SUPPLEMENTARY MEMO

SUBJECT: DA2023/0278 – 3 Pavilion Street, Queenscliff

Demolition Lower Ground Floor Plan

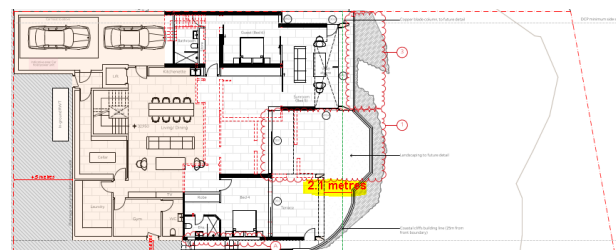
The Assessment Report states the proposed development “does not extend any further seaward beyond the existing built-upon footprint”. Mr Winton raised concern with this statement, noting that the south elevation shows amended walls to the lower ground and ground terraces, that the wall includes a door at the lower ground level, and that the works extend the building seaward. Mr Winton reiterated dissatisfaction with this element of the proposed works, with respect to access to light from his property.

A comparison of the existing/demolition and proposed lower ground floor plans demonstrate a distance of 2.1m from the edge of the lower ground terrace to the rear glass fence (being the curved line shown below):

Further, the southern elevation, existing/demolition plan and proposed lower ground floor plan all show a distance of 23.6 metres from the front boundary line to the seaward-most edge of the lower ground floor terrace. The plans demonstrate the works amount to a reconfiguration at the lower ground level, rather than an extension.

It is, however, accurate to say that there is an extension seaward at the ground level, with a 400 millimetres extension of the ground floor terrace. It was first understood that this was over the footprint of the lower ground terrace, though this is established to in fact be an extension. Notwithstanding this, at the ground level, the corresponding southern wall is extended by 100 millimetres, which will result in a negligible impact with respect to access to light. The proposed development is compliant with the
